SERVICE BULLETIN

NACELLE - EXHAUST - NO. 1 OPEN LATCH INDICATOR INSTALLATION,
THRUST REVERSER - MODIFICATION OF

June 7, 1996

V2500-NAC-78-0054

No. 1 Open Latch Indicator Removal/Installation
(Service Bulletin Part 1)
Figure 1

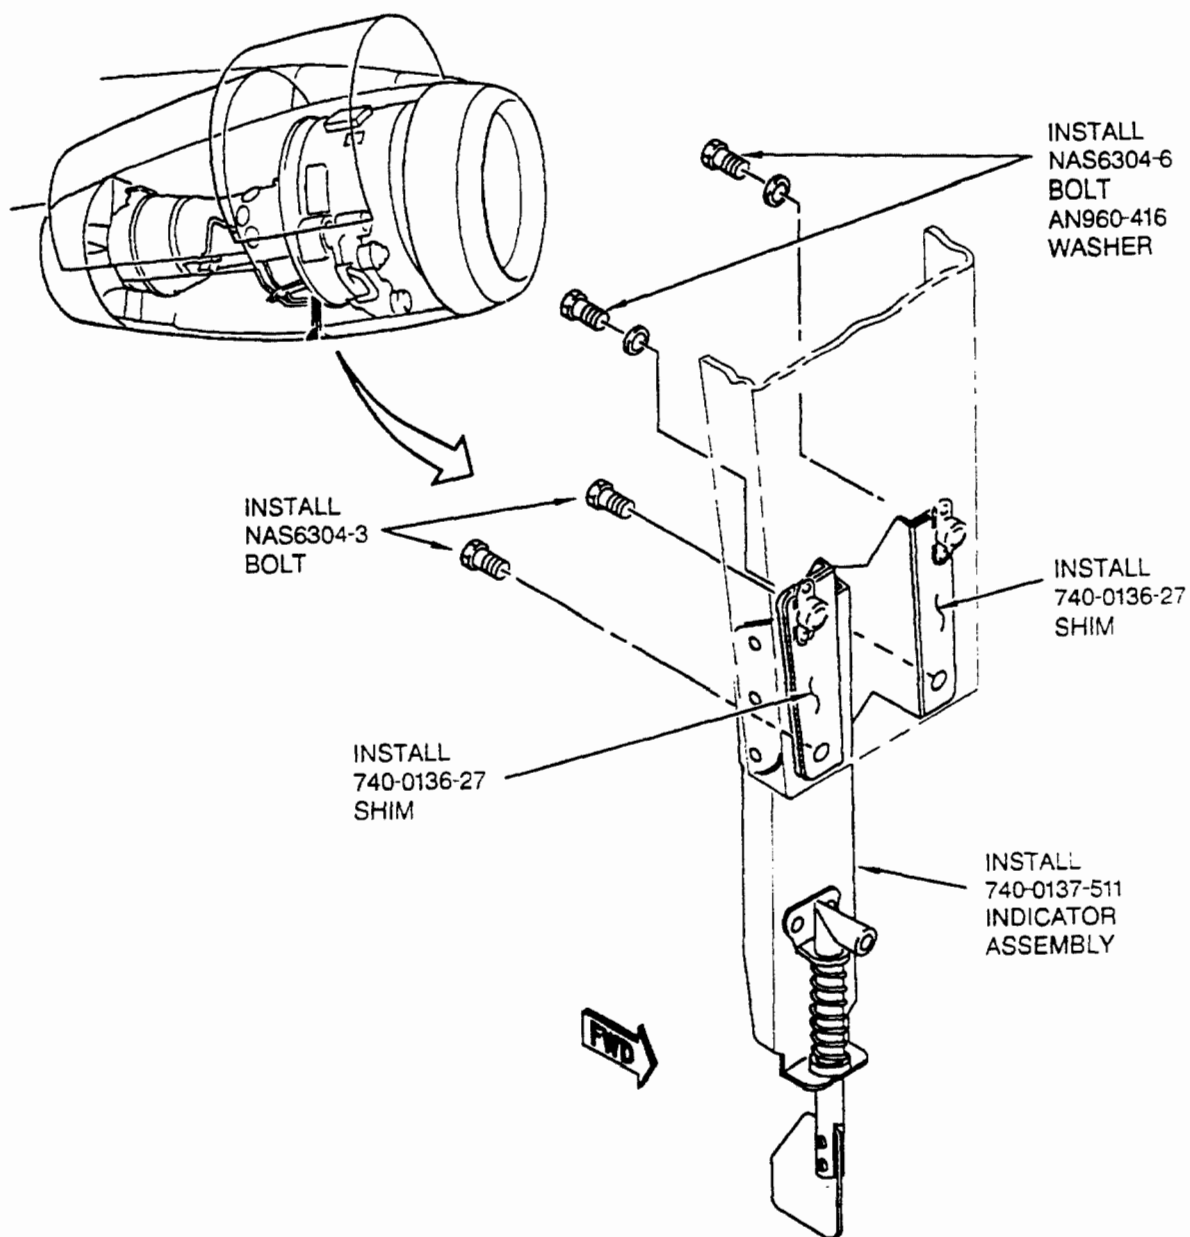
B. Indicator Assembly Removal/Installation Instructions - Part 1

(1) Remove the 740-0137-509 indicator assembly.

- (a) Remove the two NAS6304-3 bolts, two NAS6304-6 bolts, two AN960-416 washers, the 740-0137-509 indicator assembly, and the two 740-0136-27 shims from the engine. Discard the indicator assembly. Keep the shims, bolts, and washers for installation.

(2) Install the 740-0137-511 indicator assembly.

- (a) Install the two 740-0136-27 shims, and the 740-0137-511 indicator assembly on the engine with the two NAS6304-3 bolts, two AN960-416 washers, and two NAS6304-6 bolts. Tighten the bolts to a torque of 50-70 lbf·in (5.7-7.9 Nm).

No. 1 Latch Open Indicator Pad Removal/Installation
(Service Bulletin Part 2)

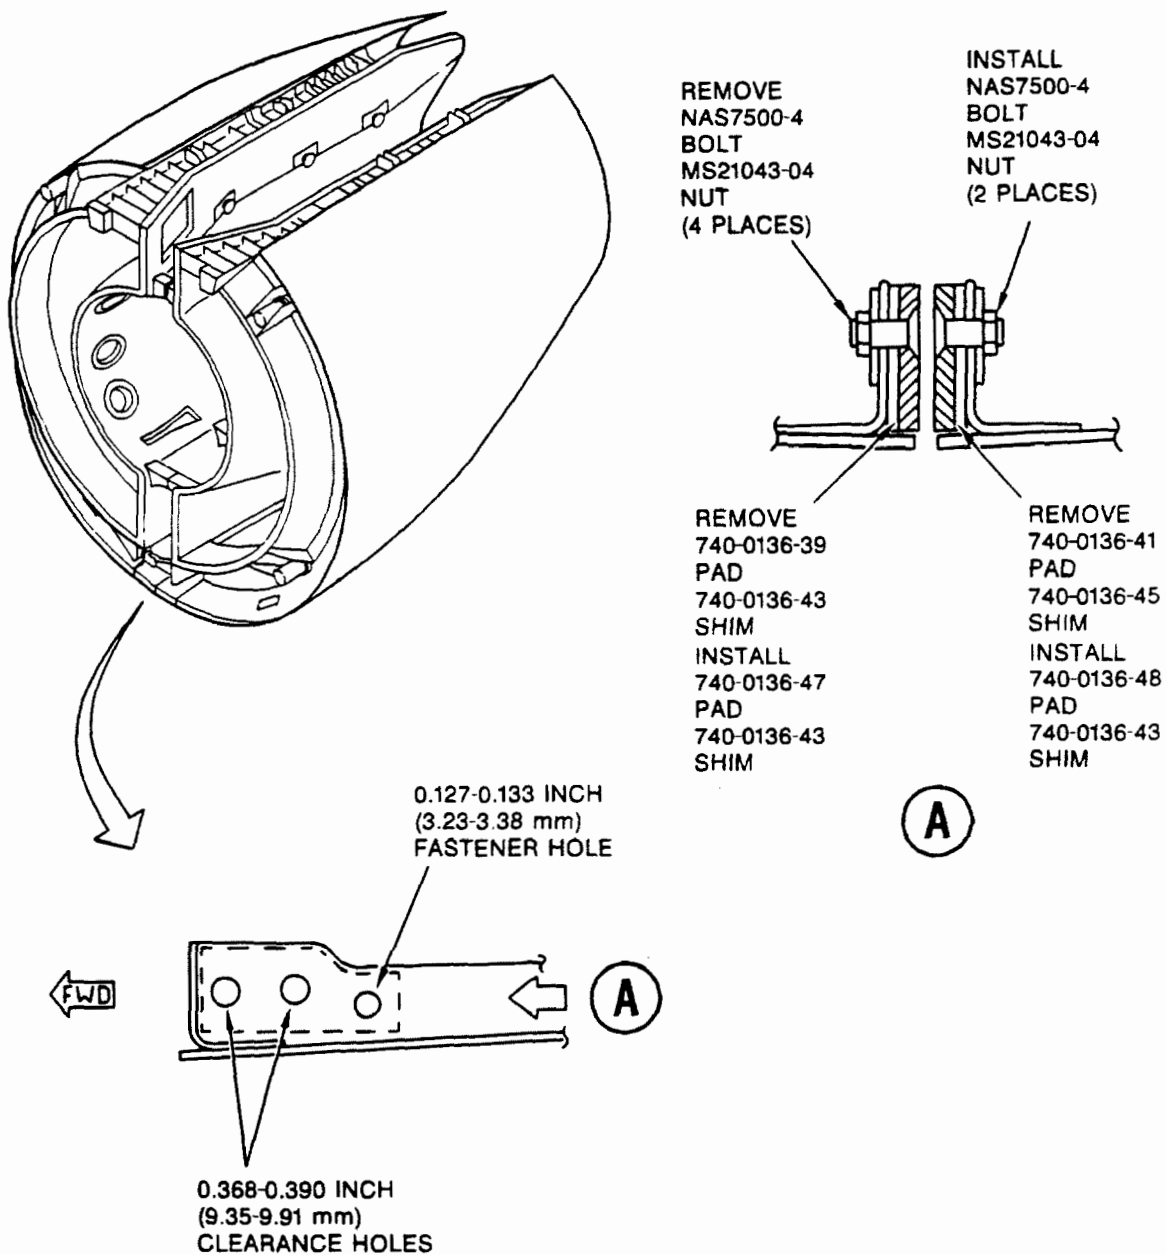
C. Thrust Reverser Guide Pads Removal/Installation - Part 2

(1) Remove the two-fastener thrust reverser guide pads.

- (a) Remove the MS21043-04 nuts, NAS7500-04 bolts, 740-0136-39/41 pads, and the 740-0136-43/45 shims from the thrust reverser halves. Discard the pads and shims. Keep the bolts and nuts for installation of the new pads and shims.

(2) Install the one-fastener thrust reverser guide pads.

- (a) Hold the 740-0136-47 pad and 740-0136-43 shim together. Make sure the shim is against the flat (not beveled) side of the pad. Backdrill the two 0.368-0.390 (9.35-9.91 mm) holes and one 0.127-0.133

inch (3.23-3.38 mm) hole through the shims. Refer to Figure 2.

- (b) Hold the 740-0136-48 pad and 740-0136-43 shim together. Make sure the shim is against the flat (not beveled) side of the pad. Backdrill the two 0.368-0.390 inch (9.35-9.91 mm) holes and one 0.127-0.133 inch (3.23-3.38 mm) hole through the shims.
- (c) Temporarily install the pads and shims with the NAS7500-04 bolts and MS21043-04 nuts. Adjust the clearance between the latch open indicator and the pads when the thrust reverser and engine are installed on the aircraft. Refer to the A320/A321 Aircraft Maintenance Manual, Chapters 78-32-01, -02, -03, and -04.

No. 1 Latch Open Indicator Pad Installation
(Service Bulletin Part 3)

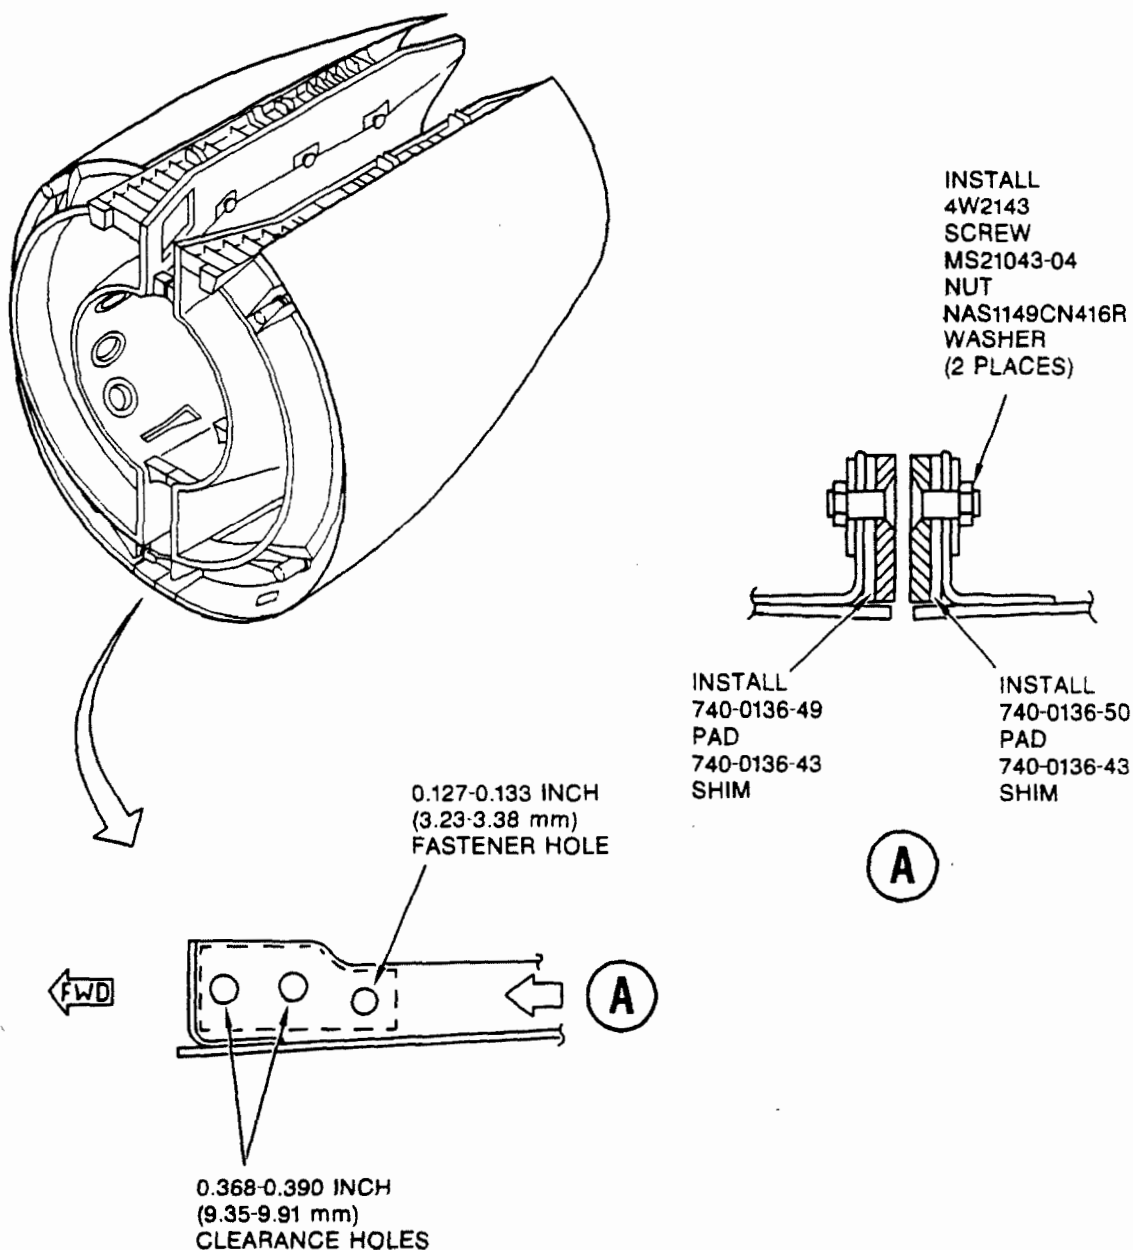
D. Thrust Reverser Guide Pads Installation - Part 3

- (1) Hold the 740-0136-47 pad and 740-0136-43 shim together. Make sure the shim is against the flat (not beveled) side of the pad. Backdrill the two 0.368-0.390 (9.35-9.91 mm) holes and one 0.127-0.133 (3.23-3.38 mm) inch hole through the shims. Refer to Figure 2.
- (2) Hold the 740-0136-48 pad and 740-0136-43 shim together. Make sure the shim is against the flat (not beveled) side of the pad. Backdrill the two 0.368-0.390 inch (9.35-9.91 mm) holes and one 0.127-0.133 inch (3.23-3.38 mm) hole through the shims.
- (3) Put the pads and shims on the thrust reverser halves and back drill a 0.127-0.133 inch (3.23-3.38 mm) hole through the lower track.
- (4) Temporarily install the pads and shims with NAS7500-04 bolts and MS21043-04 nuts. Adjust the clearance between the latch open indicator and the pads when the thrust reverser and engine are installed on the aircraft. Refer to
